PRODUCT BULLETIN

PB NO.109
REV. 2

SUBJECT: Pilot Fuel Check Valve
Superior Clean Burn Engine
Part Number P-031-665-Y-1 Inline Engine
P-031-665-V Vee Engine

TOLERANCES (EXCEPT AS NOTED)		ENERGYDYNAMICS, INC.	
DECIMAL	±	SCALE NONE	DRAWN BY J. Terrell
FRACTIONAL	±	APPROVED BY JS	
ANGULAR	±	TITLE CHECK VALVE ASSY. - PILOT FUEL	
		DATE 8-27-93	DRAWING NUMBER P-031-665-Y-1

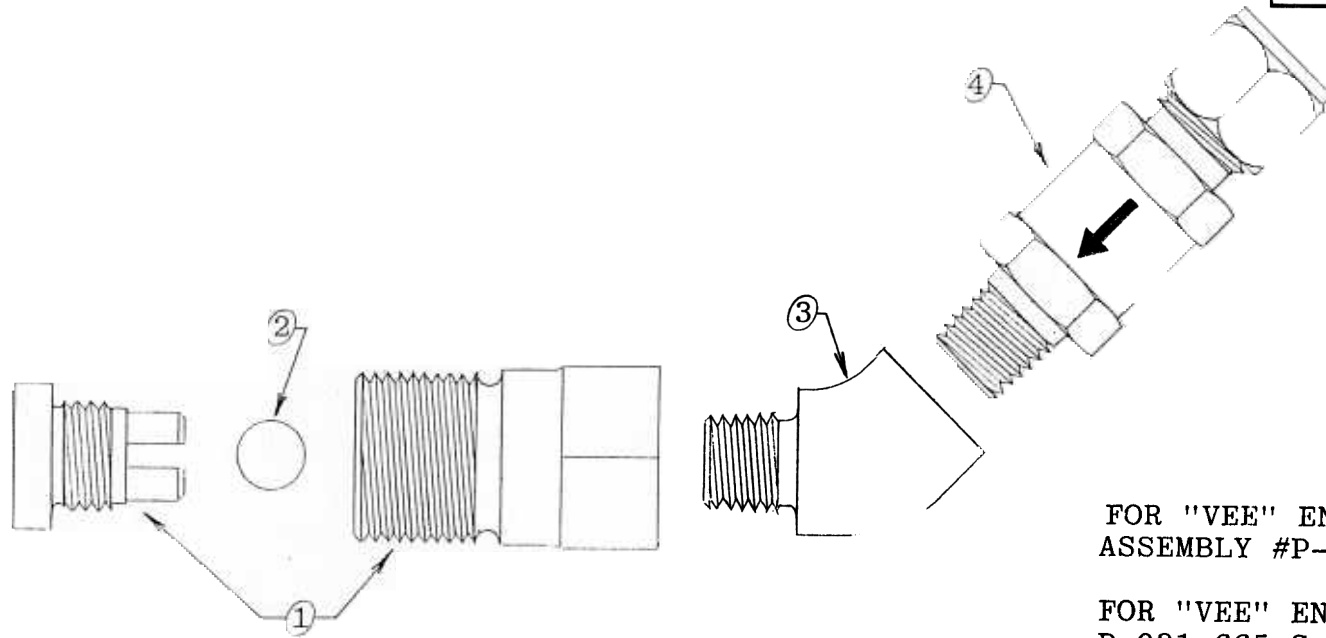
The attached drawing reflects another improved design **PowerPart®**. **EnDyn** new pilot fuel double check valve has been installed in Superior Clean Burn Engines in excess of (12) months resulting in no downtime for removal and cleaning.

The male thread size is 7/8" X 14 and is interchangeable with your existing 7/8" check valve. The only required change is a slightly longer piece of tubing to the inlet connection (inline engines only).

In older engines utilizing the smaller 3/4" X 16 check valve, it will be necessary to rework your existing cylinder heads to accept the larger 7/8" check valve.

We also suggest that the combustion chambers be blown out after removal of the old check valve and prior to the installation of the new valve. This will remove any excess carbon stuck in the check valve passage way.
